Monitoring Report
FINAL VERSION
Horne Creek Tributaries Mitigation Project
Monitoring Year 3
Calendar Year of Data Collection: 2022

NCDEQ DMS Project Identification # 100026
NCDEQ DMS Contract # 7181
Yadkin River Basin (Cataloging Unit 03040101)
USACE Action ID Number: SAW-2017-01510
NCDEQ DWR Project # 2017-1156
Surry County, NC
Contracted Under RFP # 16-006993, Date of Issue: August 16, 2016
Data Collection Period: July - October 2022
Submission Date: November 2022

RE: WLS Responses to NCDEQ DMS Review Comments for Task 9 Submittal, Monitoring Year 3 Report for the Horne Creek Tributaries Mitigation Project, DMS Full-Delivery Project ID #100026, Contract #7181, Yadkin River Basin, Cataloging Unit 03040101, Surry County, NC

FIGURE
1

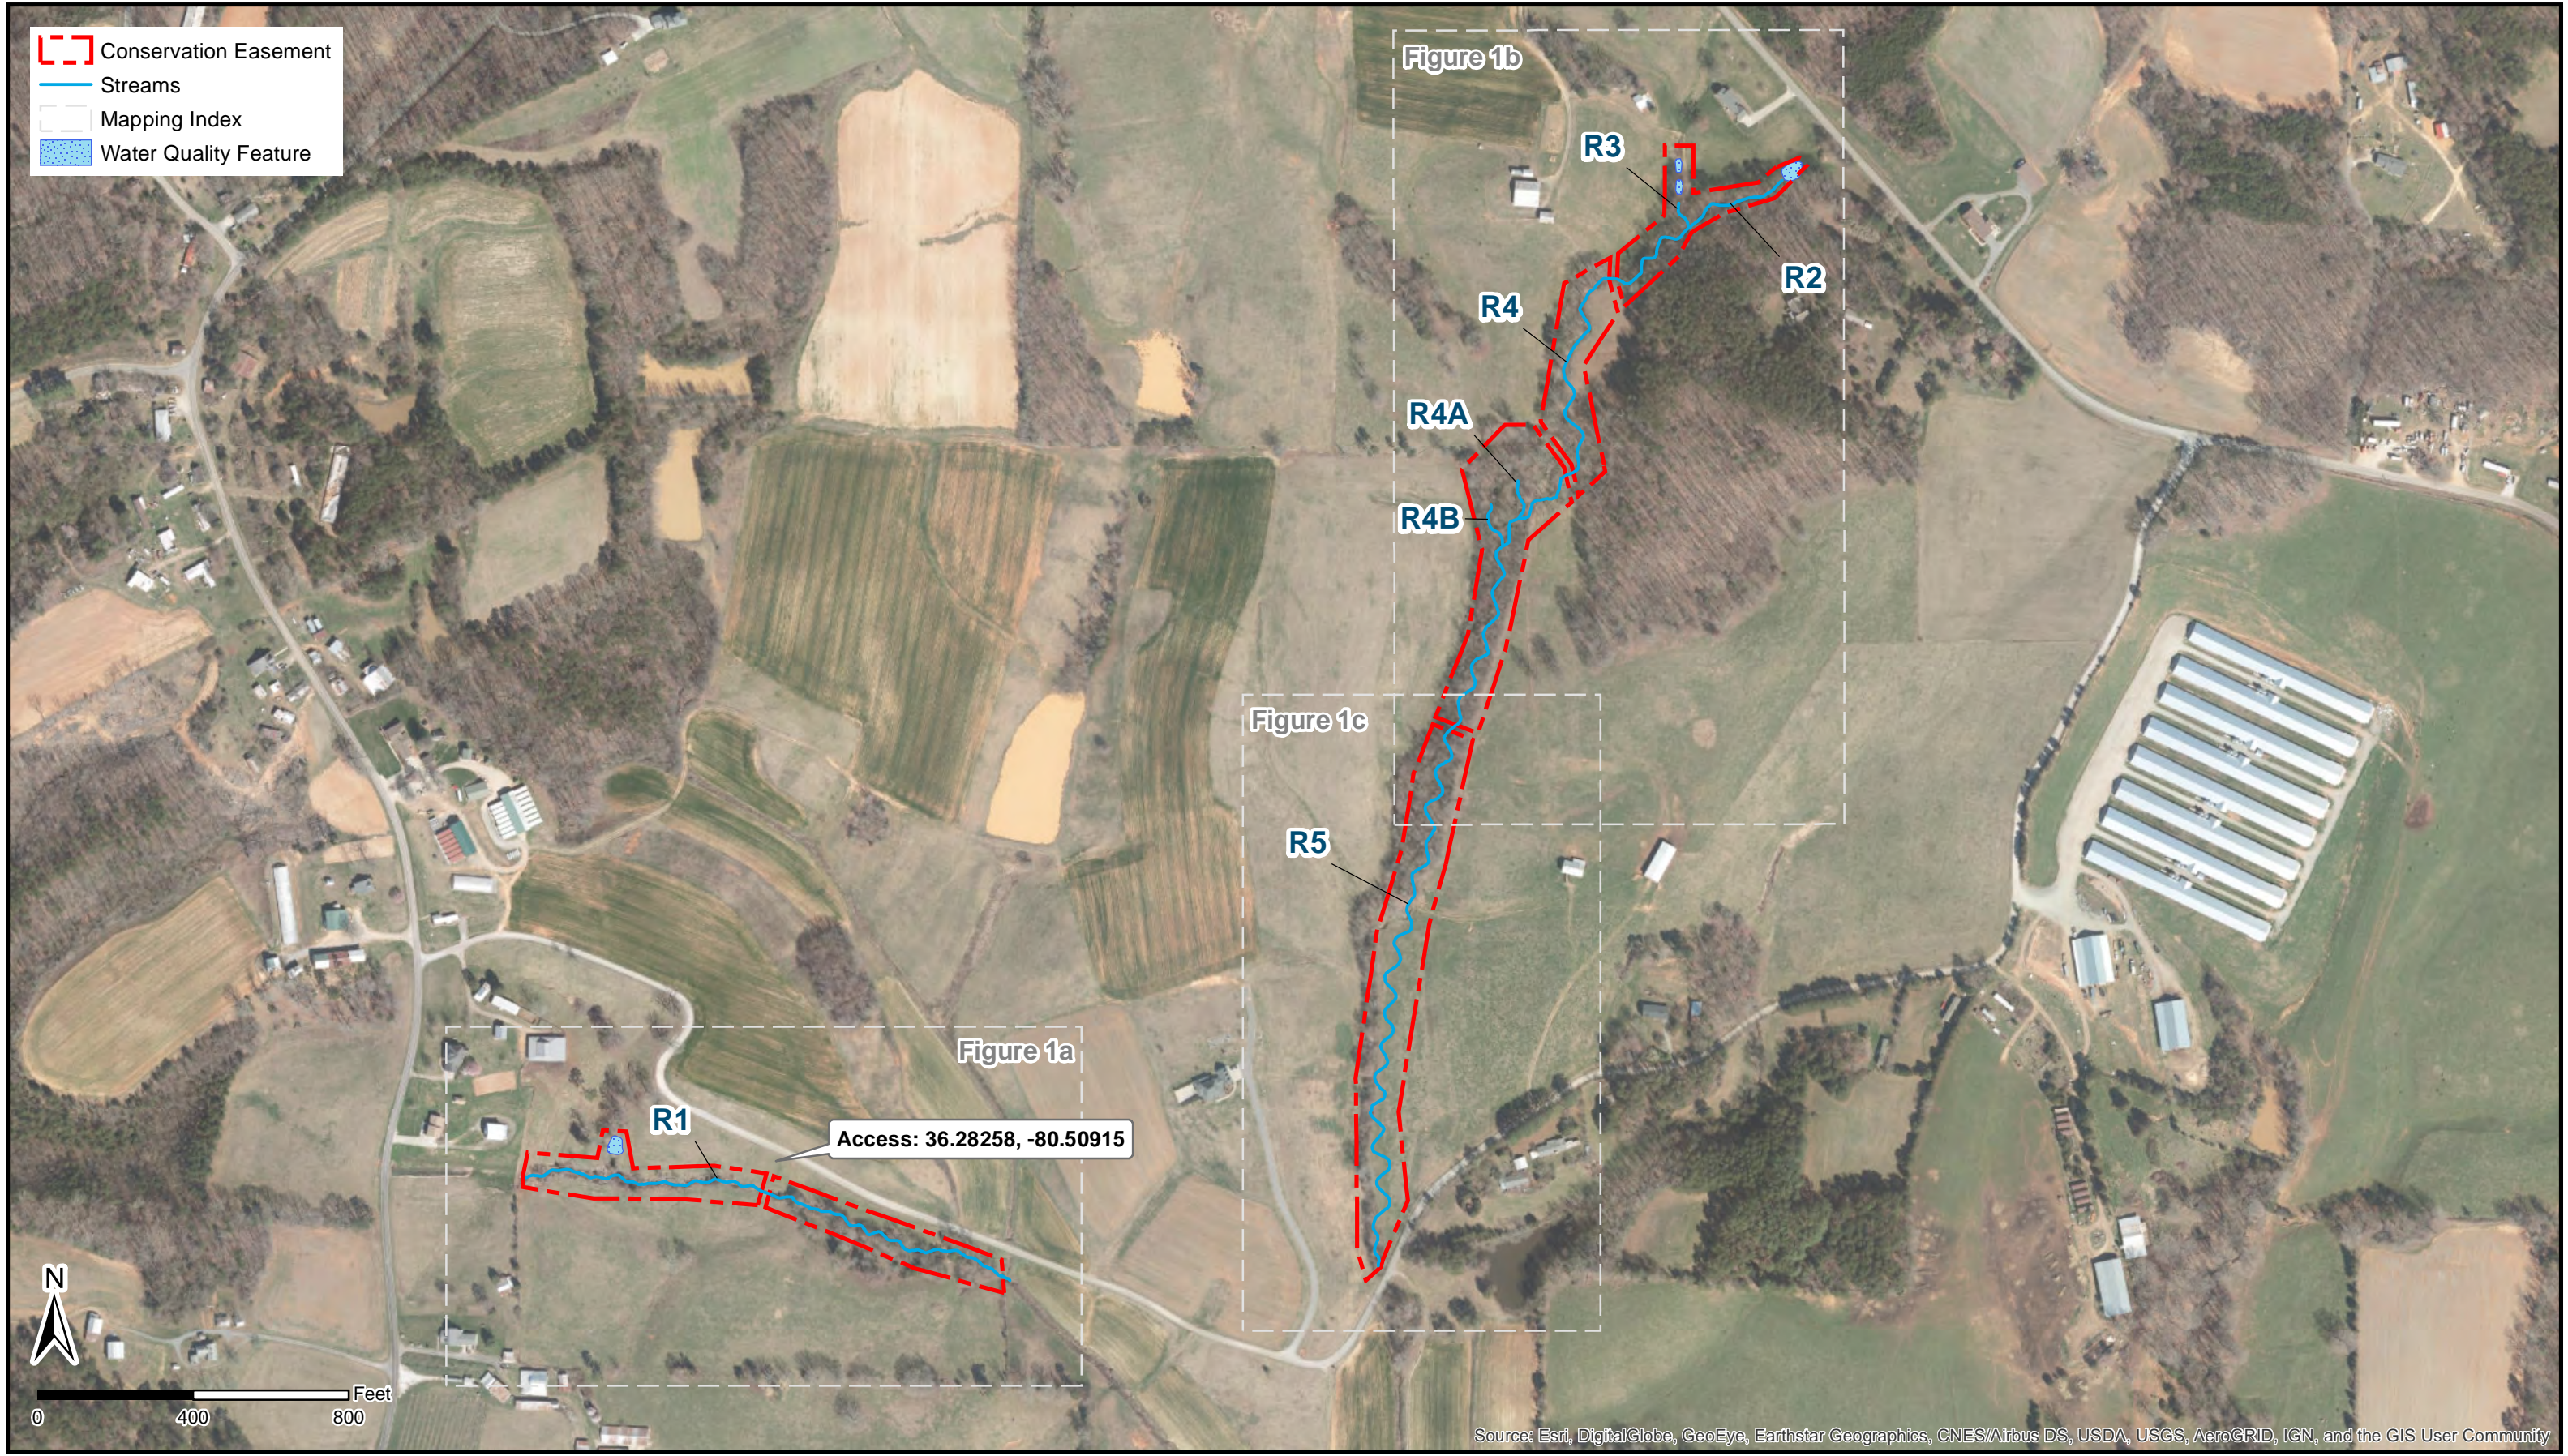
- **Title Page: Please add (Date of Issue: August 16, 2016) following the RFP#.** Response: The title page is updated as requested.
- **Please include the CCPV overview sheet (figure 1 in previous reports) in final submittal.** Response: The CCPV overview sheet has been added to the final monitoring report.

FIGURE
1C

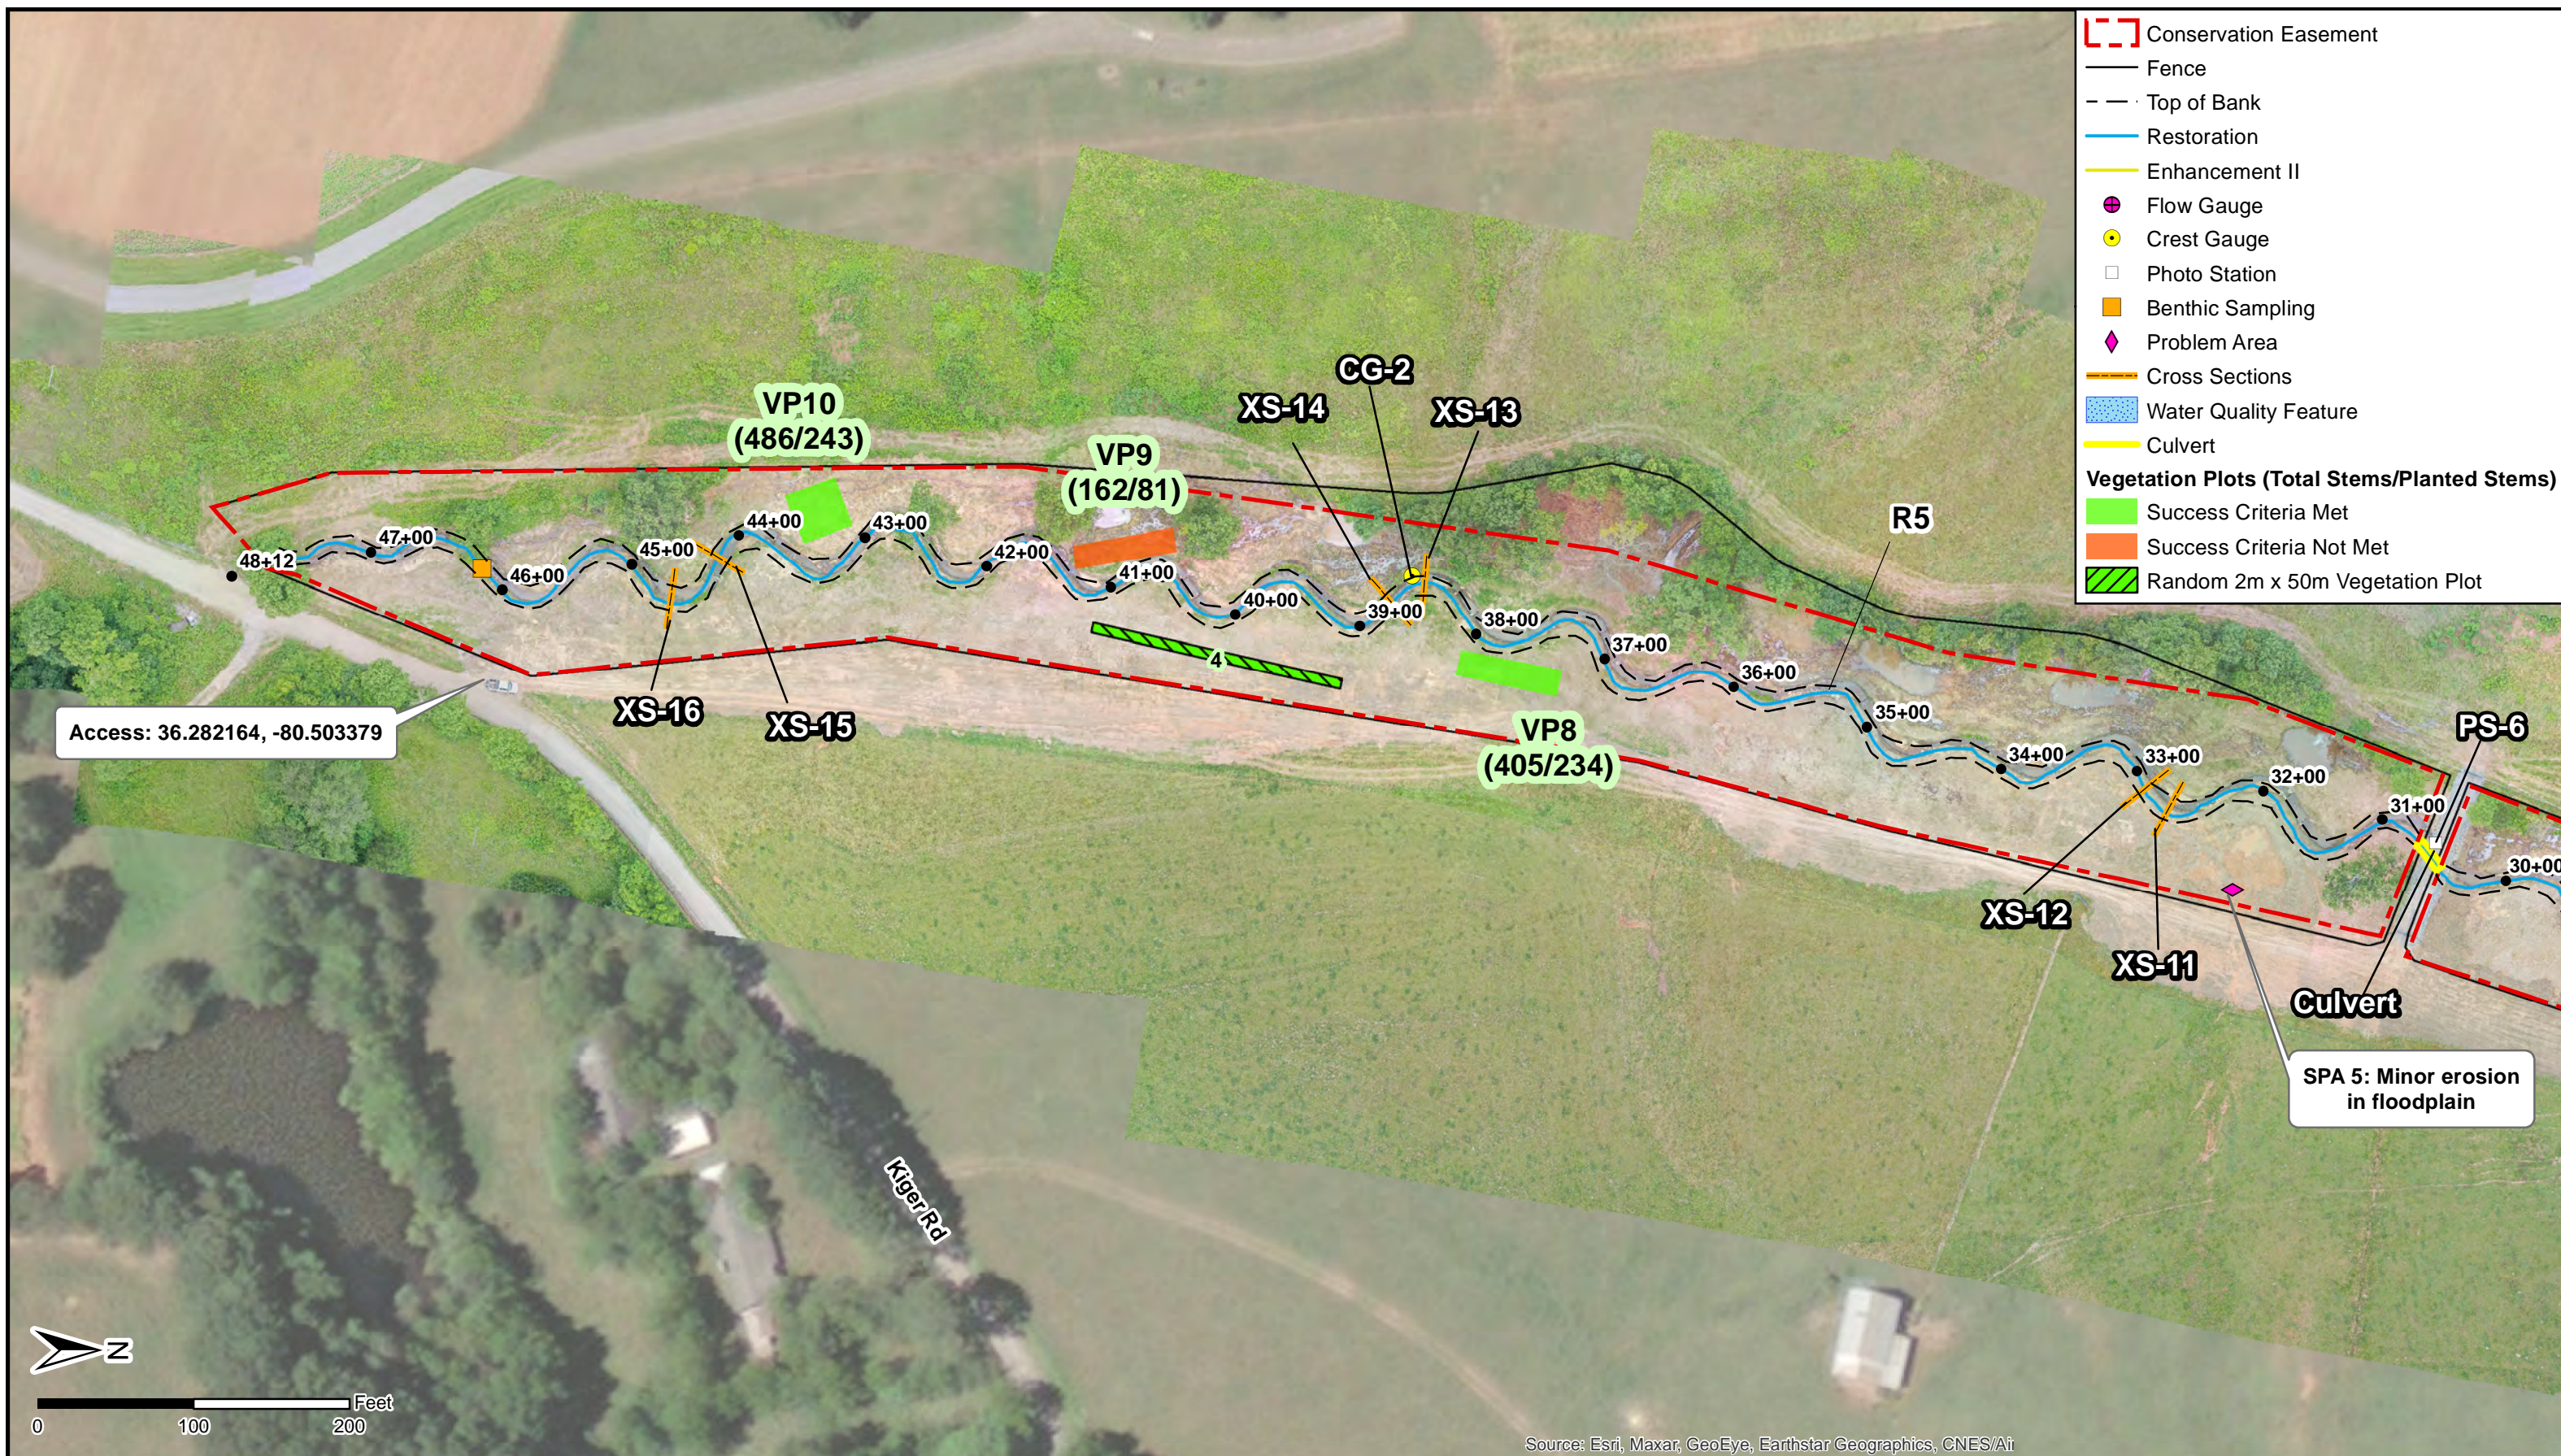
- **Thank you for including updated picture of SPA5. Please provide update and photos once the area is repaired in MY4 report.** Response: WLS will continue to provide updates and photos of SPA5 in the MY4 report
